F RSTECH, LLC. SUPPORT - 1(888) 820-3690, EXT. 203

Overview: The initial production release of the FTI-TLK1 harness has an issue where in some vehicles the secondary power input to the CN1 connector will overload the associated vehicle circuit, causing a fuse to blow. This issue affects the initial release of harnesses and is already being addressed in production. A field correction procedure is detailed below in Figure 1.

Figure 1: Step by step adapter correction

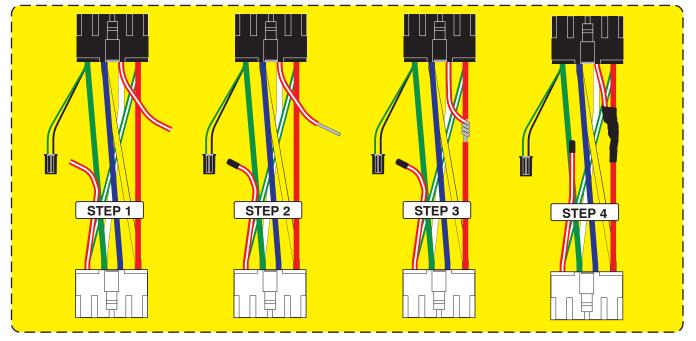
Issue: The secondary power circuit can overload some vehicle ignition switch circuits, causing a blown 5A/7.5A AM1 fuse, potentially disabling the vehicle and leaving the consumer stranded. Affected adapters are illustrated below in figure 2.

- 1.) Select the applicable CN1 adapter, isolate the RED/WHITE power wire, cut wire approximately 4" from the BLACK plug
- 2.) Insulate the wire still connected to the WHITE plug using heat shrink tubing, and strip the insulation on the other wire end
- 3.) Strip a portion of the insulation from the RED wire, attach the stripped RED/WHITE to the exposed RED wire, solder together
- 4.) Apply insulating tape to the soldered connection and secure the cut ends back to the bundle of wires created by the adapter
- 5.) Correction complete, you may safely proceed to finish your installation
